Comment Date: January 27, 2012 16:38:15PM
Supplement to the Draft Solar PEIS
Comment ID: SEDDSupp20140

Re: Comments of enXco, Inc. on the Supplement to the Draft Solar Programmatic Environmental Impact Statement

Figure 1

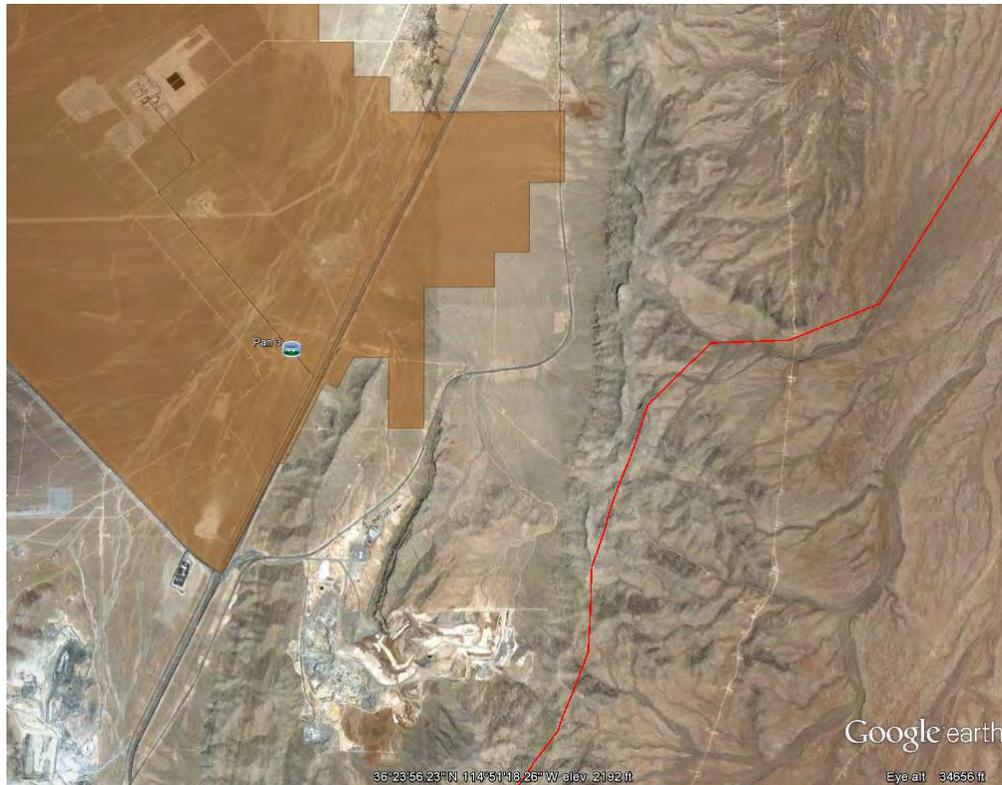
The SDPEIS proposes removing the portion of the Dry Lake SEZ lying southeast of I-15 due to concerns regarding potential impacts to the Old Spanish National Historical Trail.¹¹ However, as the KMZ files for the Draft PEIS attest, this portion of the originally proposed Dry Lake SEZ is almost entirely screened from the Old Spanish National Historical Trail by an intervening ridge of the Dry Lake Range (See Figure 1, below). In addition, the trail turns east and away from the SEZ at approximately the same point it reaches the portion of the original SEZ lying southeast of I-15. Moreover, if a viewer follows the trail at ground level on Google Earth, the few mountain-top locations along the trail where the SEZ can be viewed reveal the SEZ lands *west* of the I-15; lands to the east of the I-15 for the most part remain obscured from view due to their close proximity to the base of the intervening ridge. Figures 2 and 3 below illustrate this effect by showing where the trail is visible (in red) from the I-15 (Figure 2) and from the eastern edge of the original SEZ (Figure 3). Because the lands east of I-15 for the most part cannot be seen from the Old Spanish National Historical Trail (and in fact appear to be less visible than the rest of the SEZ), enXco requests their reincorporation into the Dry Lake SEZ.

Variance Areas (in blue) near the Big Pine Paiute Reservation proposed for large scale solar development under the *Modified Solar Energy Development Program Alternative (BLM Preferred Alternative)*.

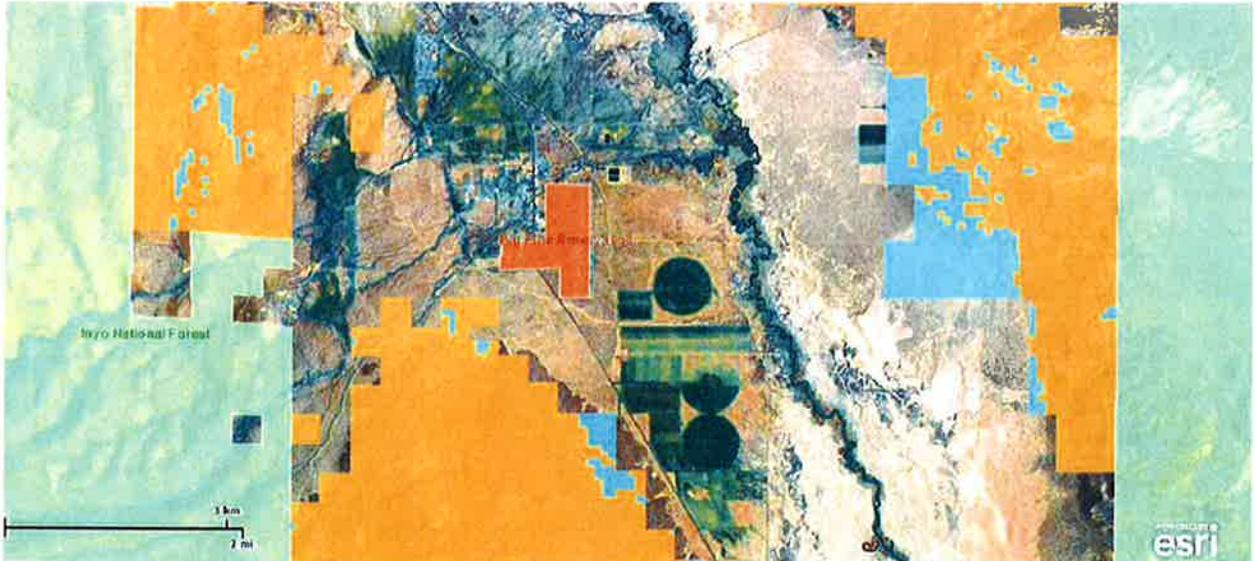
The variance areas near the Big Pine Indian Reservation, located east of the Reservation, near the base of the Inyo Mountains, and in the lava flow blackrock country south of the Reservation, are exactly the same as the designations for solar development presented in the draft PEIS (see Attachment 1). These lands are regarded as traditional Tribal territory. The Owens Valley Paiute cultural landscape would be permanently harmed if large-scale solar development were to occur in the designated variance areas. The Modified Solar Energy Development Program Alternative (BLM Preferred Alternative) should be rejected, and the Tribe is opposed to all variance areas in all six southwestern states of the project.

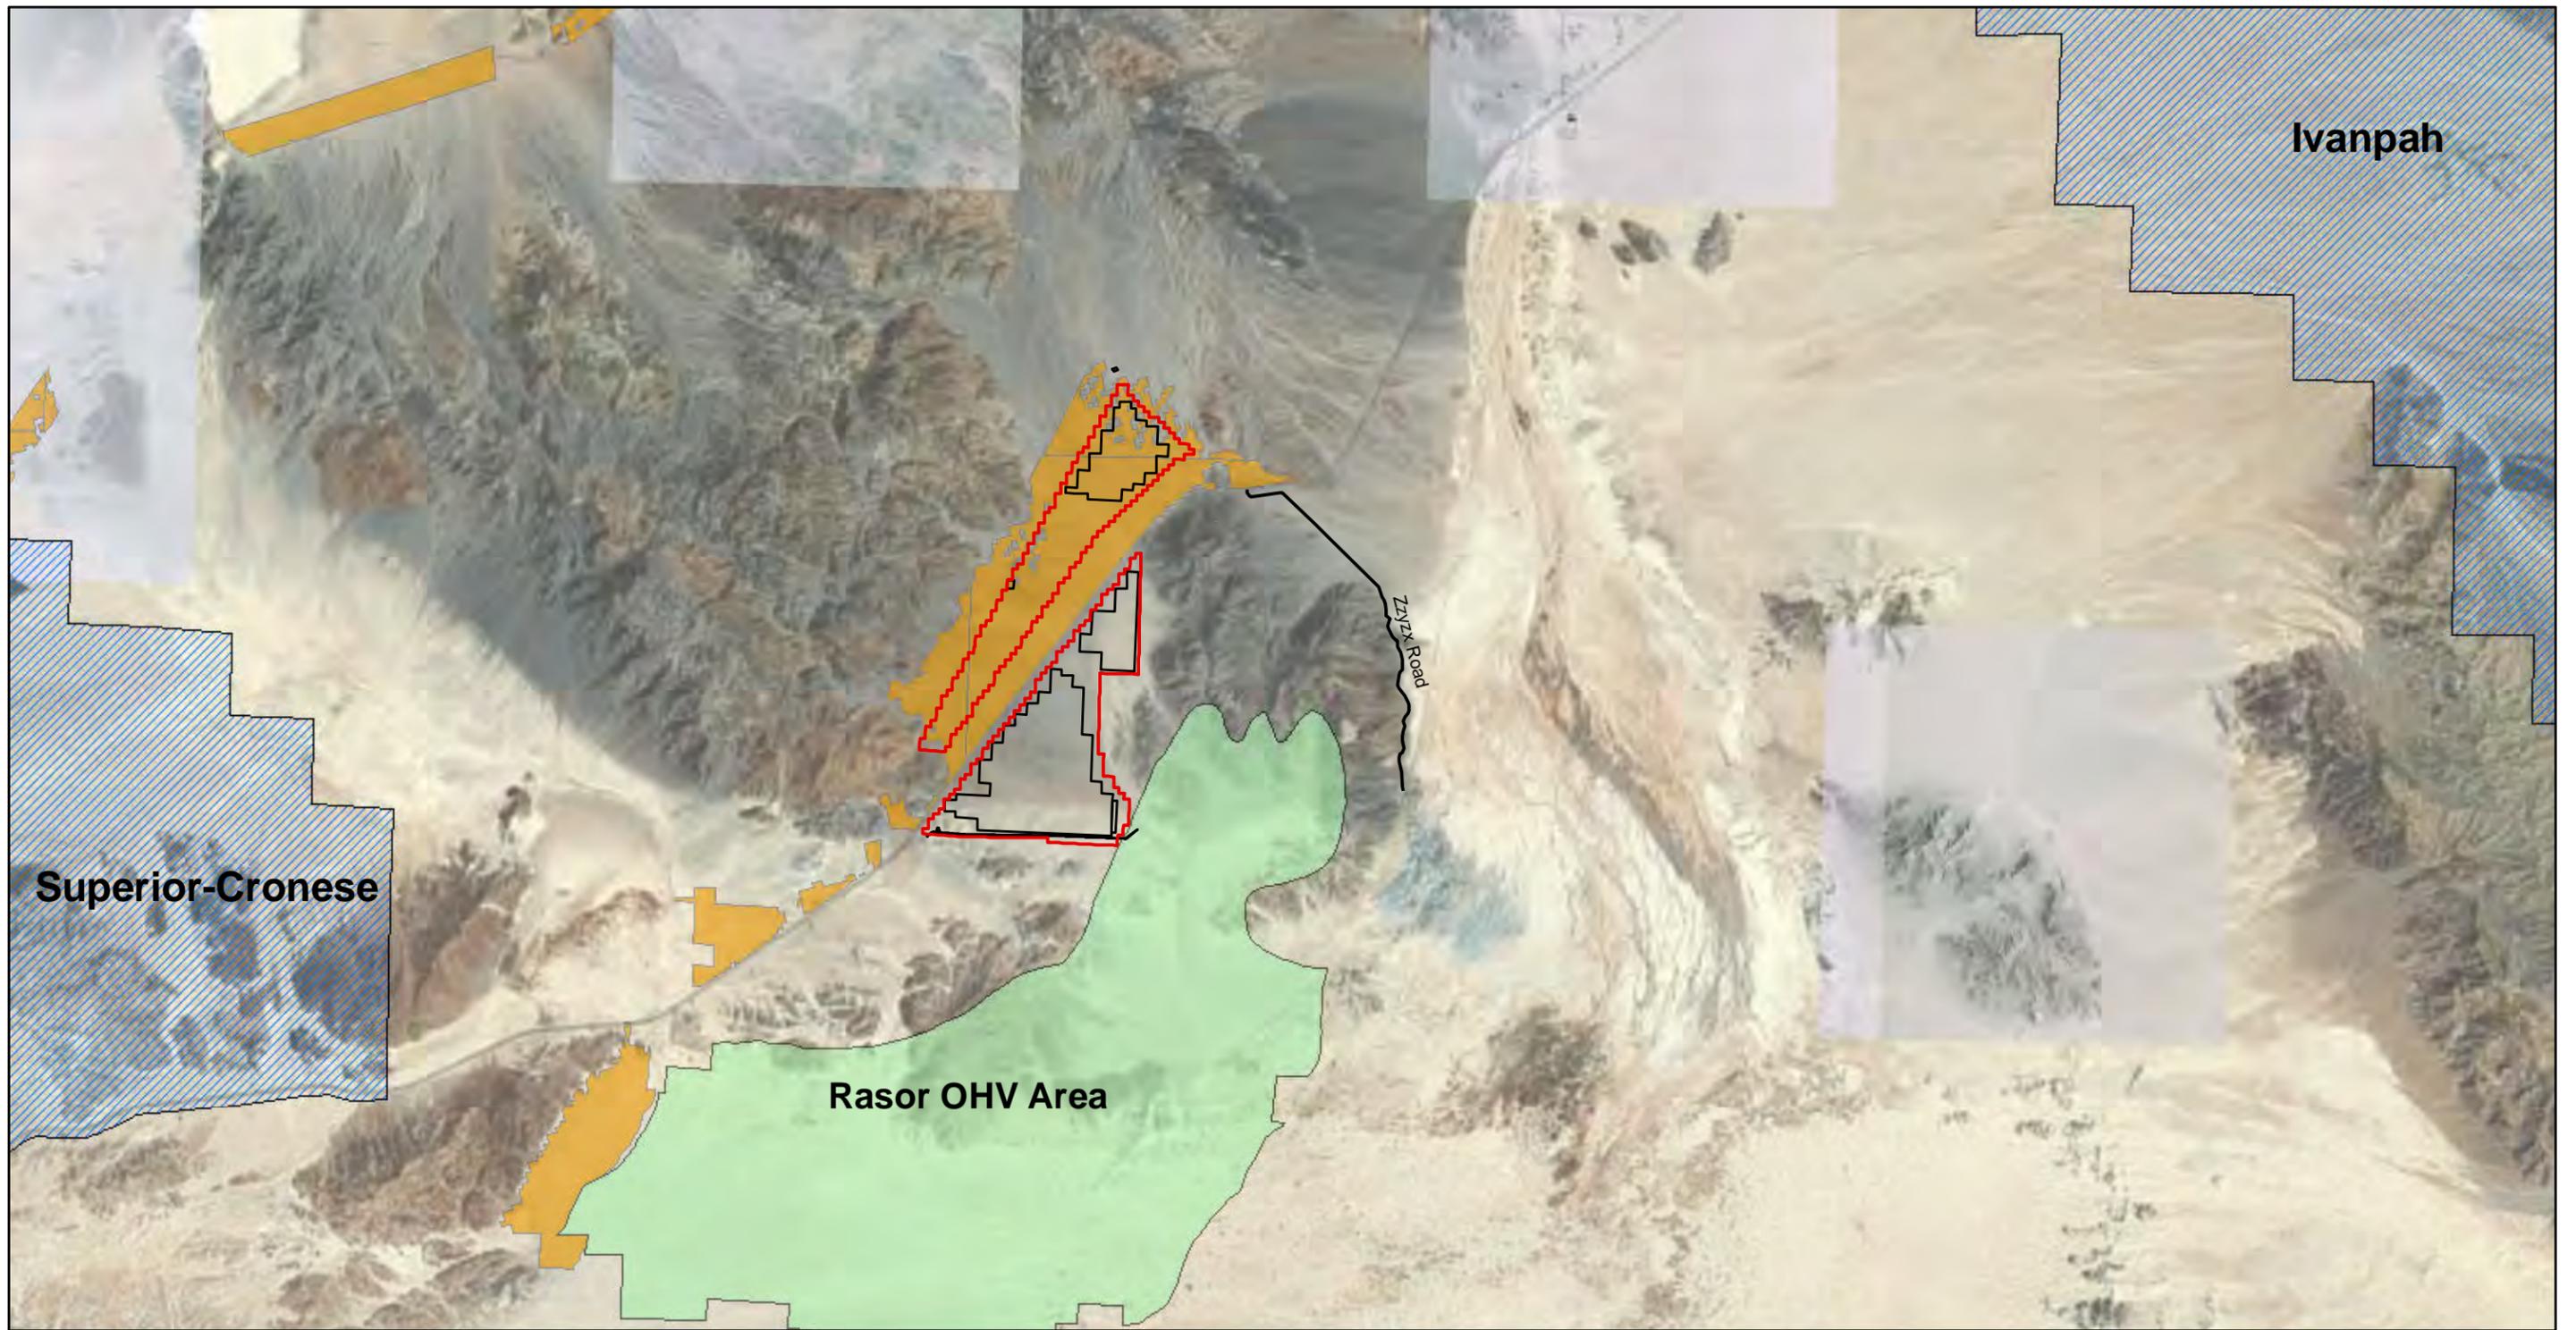
The proposed connectivity area in the Soda Mountains area is surrounded by barriers to tortoise movement. Figure 1 shows the topography of and around the proposed connectivity area. The south and east portion of the connectivity area is bounded by I-15, which serves as an effective barrier to tortoise movement to the south and east, as does the Razor Road Off Highway Vehicle Area (Figure 2). The Soda Mountains surround the proposed connectivity area and serve as a barrier to tortoise movement from the connectivity area to the north, east and west. Moreover, Baker Sink, part of a north-south low topography feature and desert wash complex located to the east of the connectivity area, and Soda Lake, the dry playa Baker Sink drains into, have also been identified as areas of low potential for tortoise occurrence (Hagerty et al. 2010). In

Figure 2: Land Use

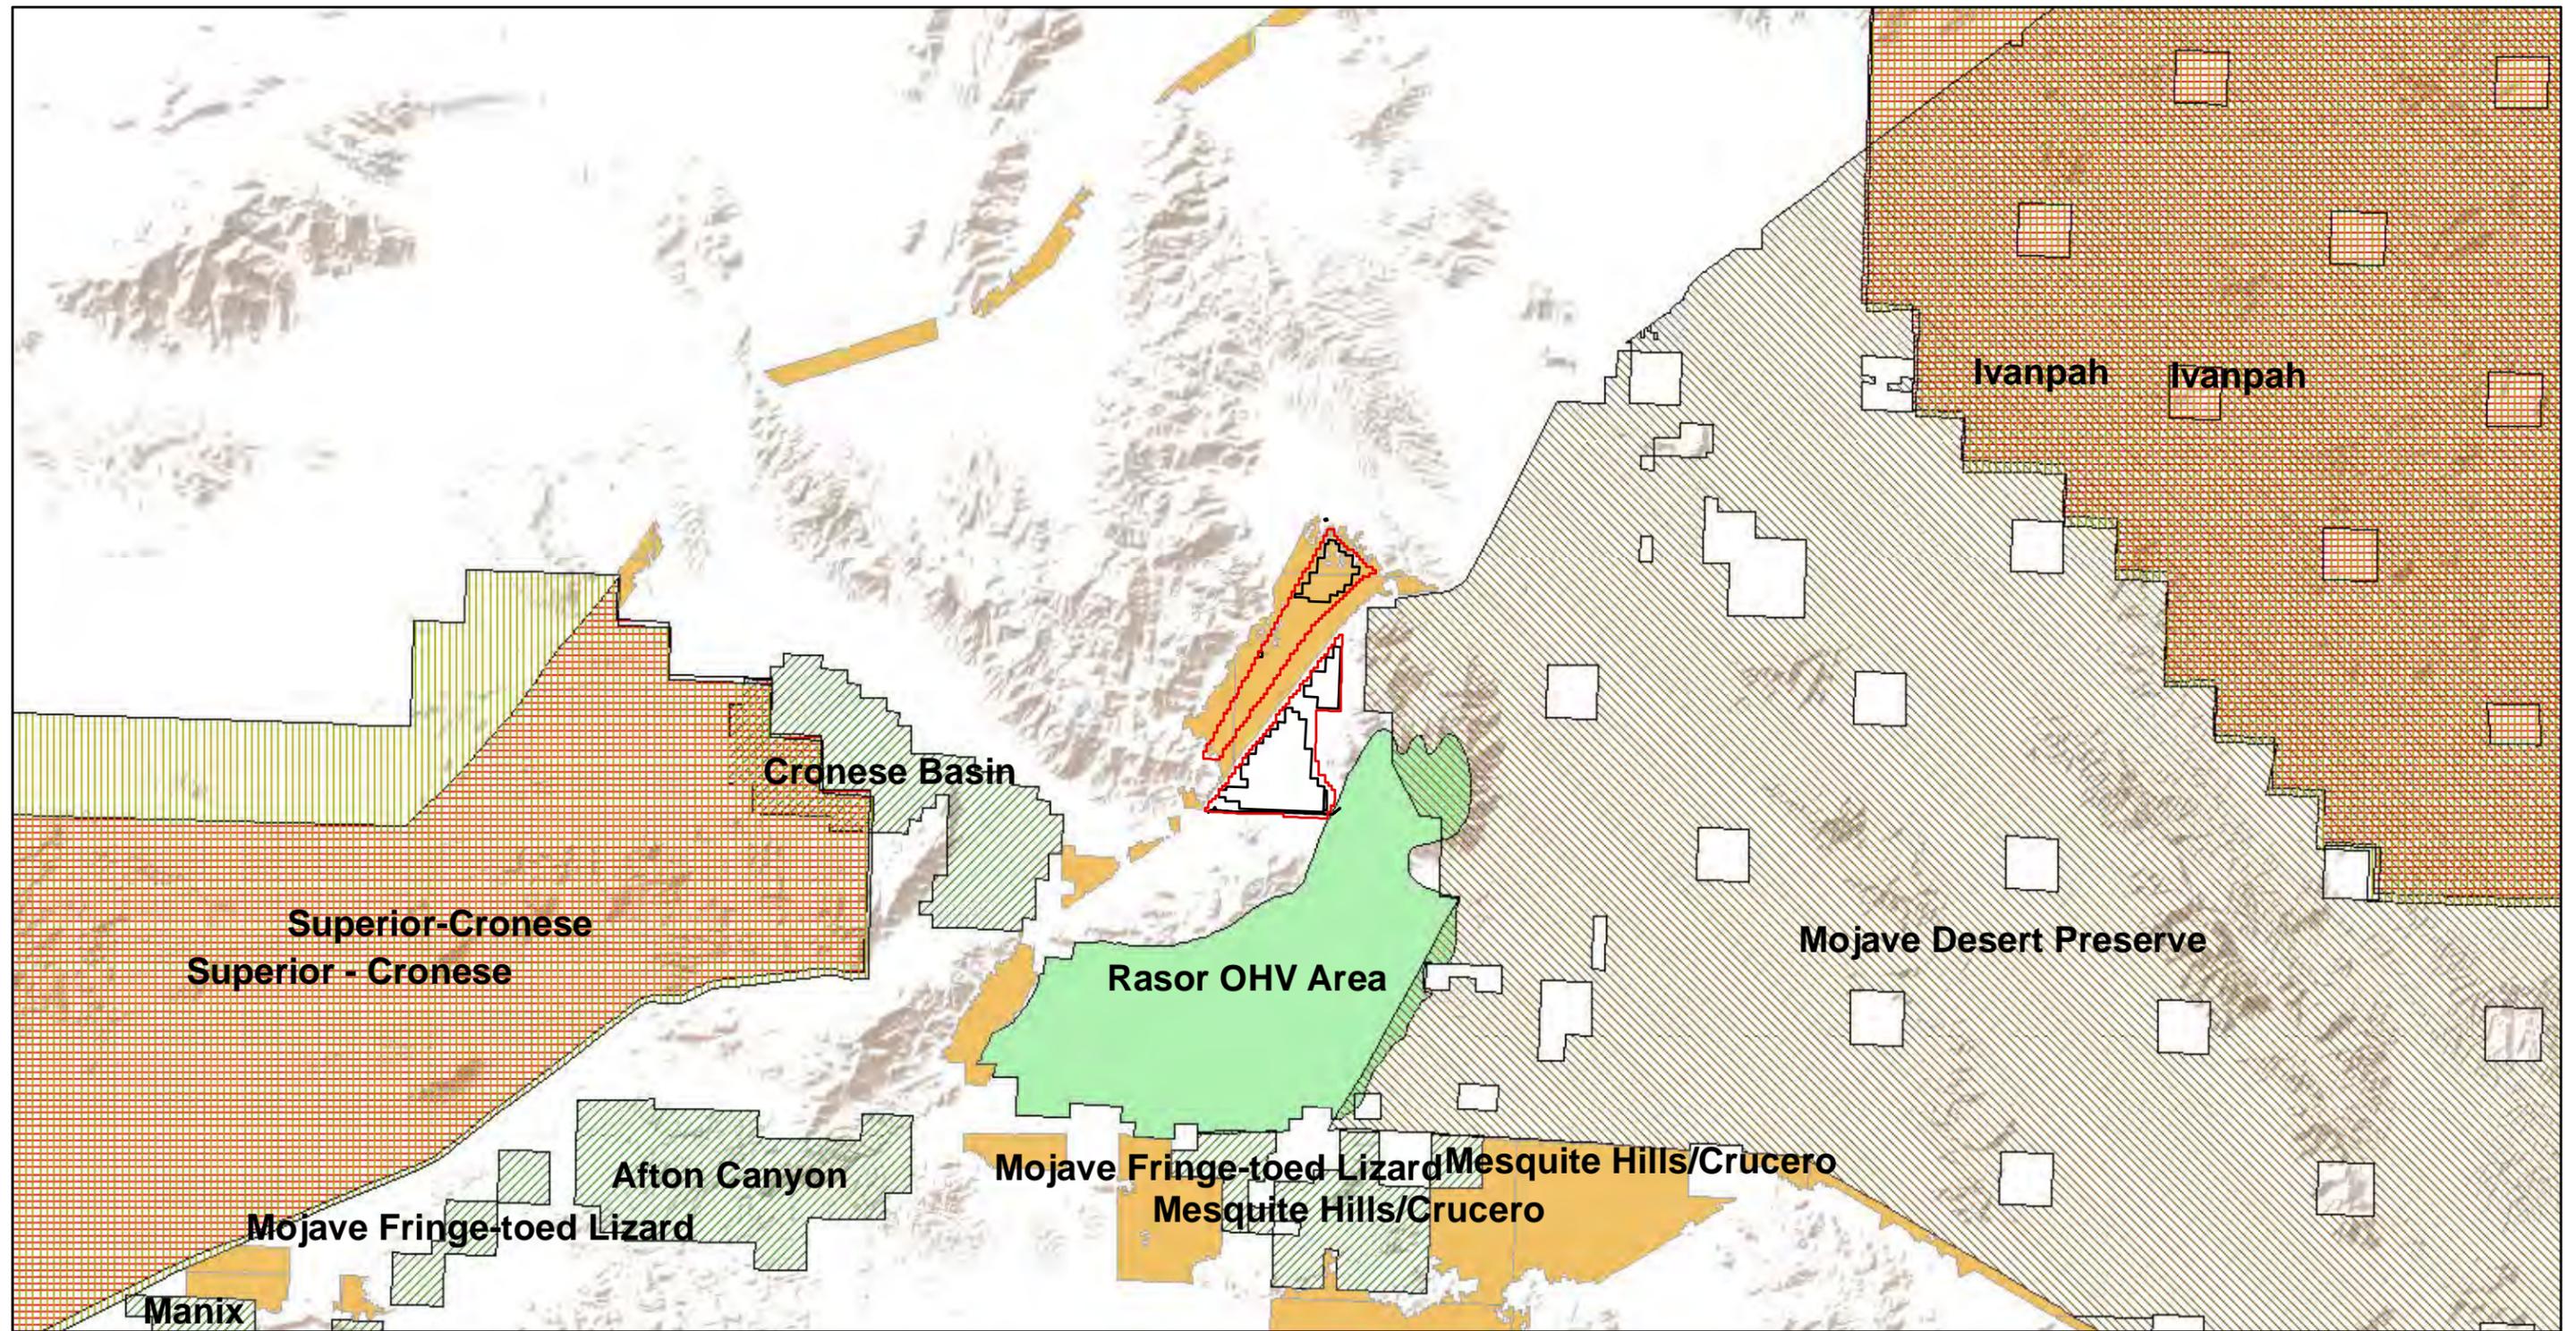
But for the barriers mentioned above, the proposed connectivity area might seem to be a logical corridor to the MNP because of its proximity, and it is on this basis that the proposed connectivity area appears to be drawn: to provide connectivity northwards from the Cronese Basin Area of Critical Environmental Concern, through the portion of the Soda Mountain Solar Project site lying to the northwest of I-15, and then eastwards under I-15 and into the MNP (Figure 2).
